ADDENDUM NUMBER ONE

DATE: March 28, 2019

PROJECT: City of Myrtle
Renovations to 13th Ave. South for Facilities Maintenance

J5 **TYPICAL ROOF SOFFIT**
A4.0 SCALE: 3"=1'-0"

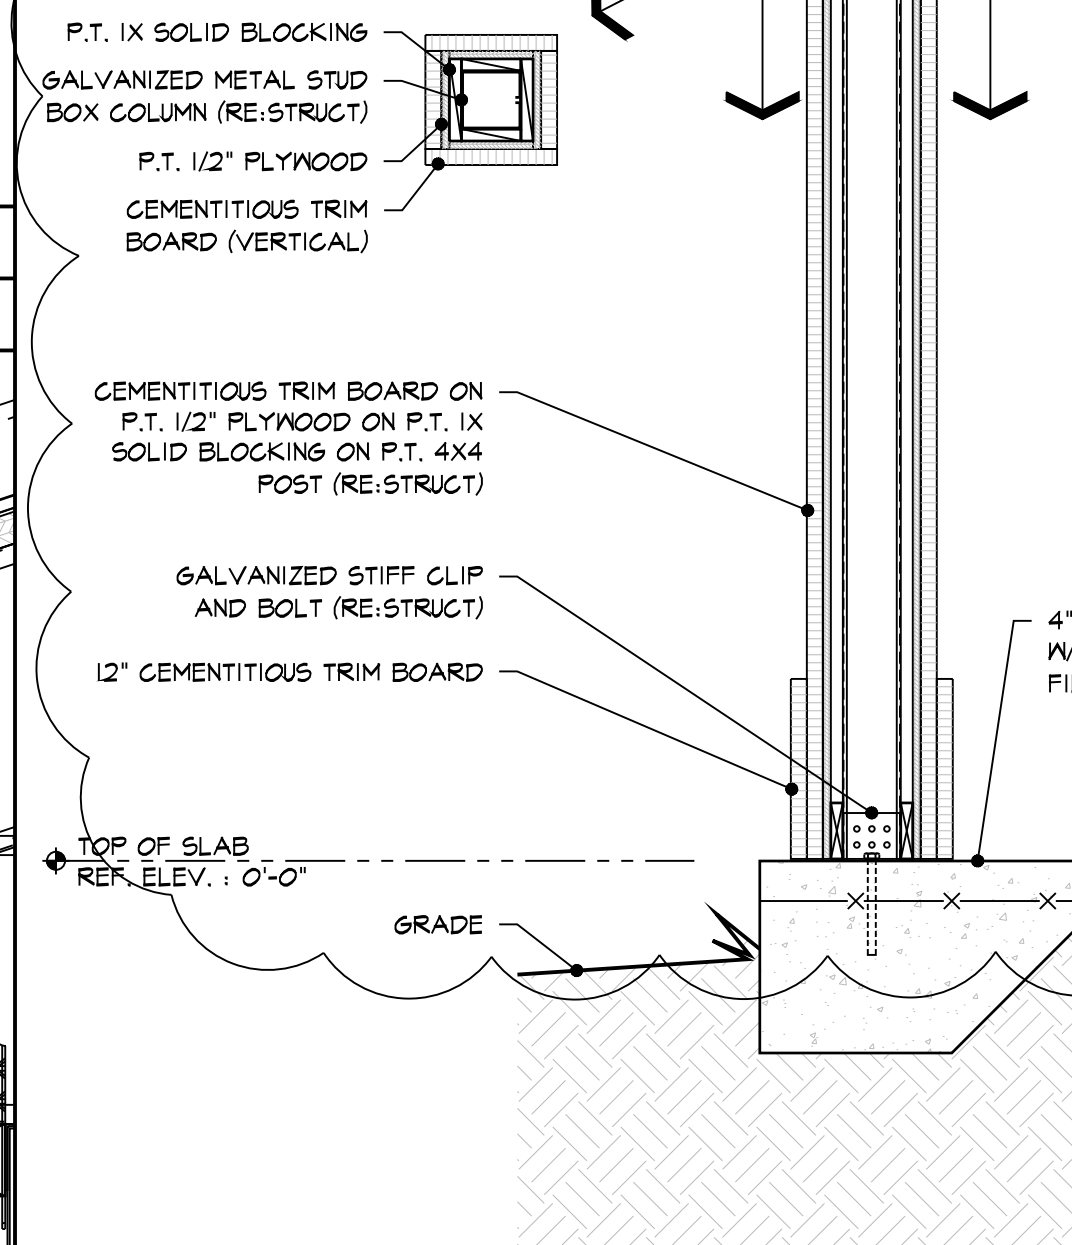
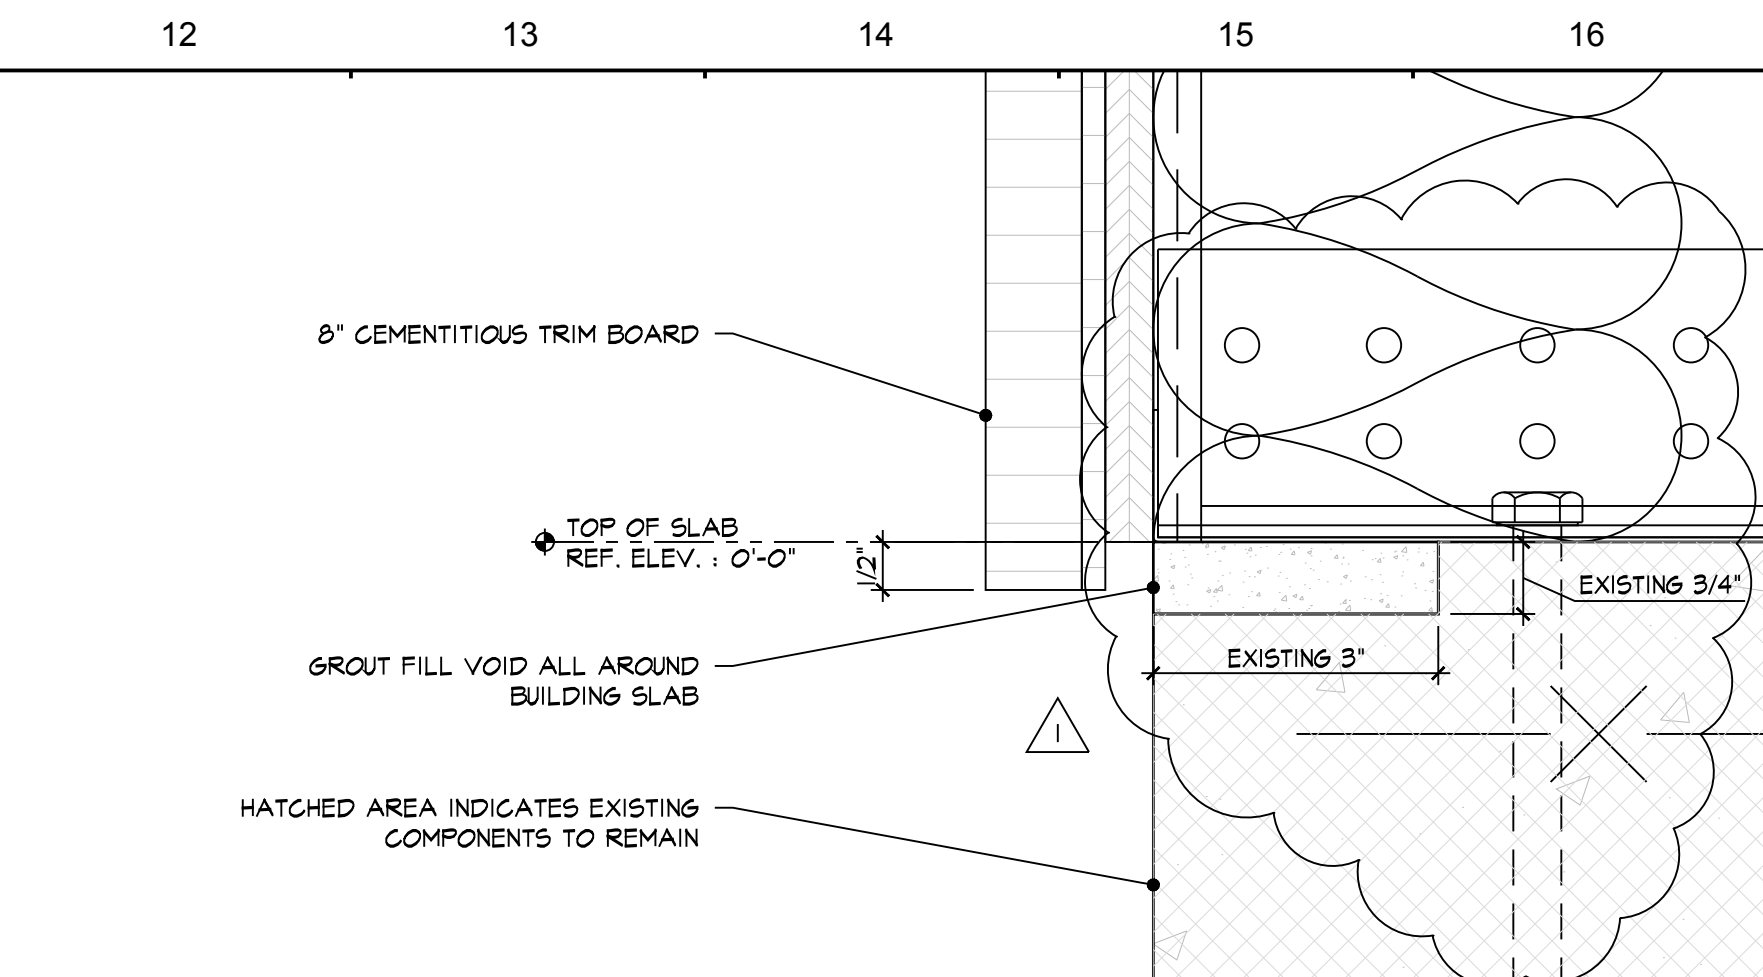
Revisions reflect modification of porch framing from wood to metal studs and metal decking.

S1.0

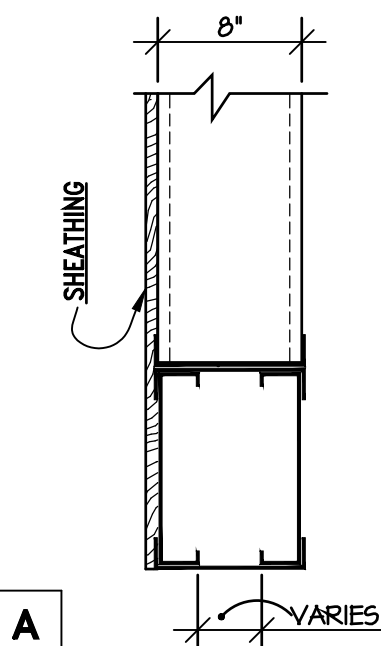
Refer to modification of the porch framing from wood to metal studs and metal decking.
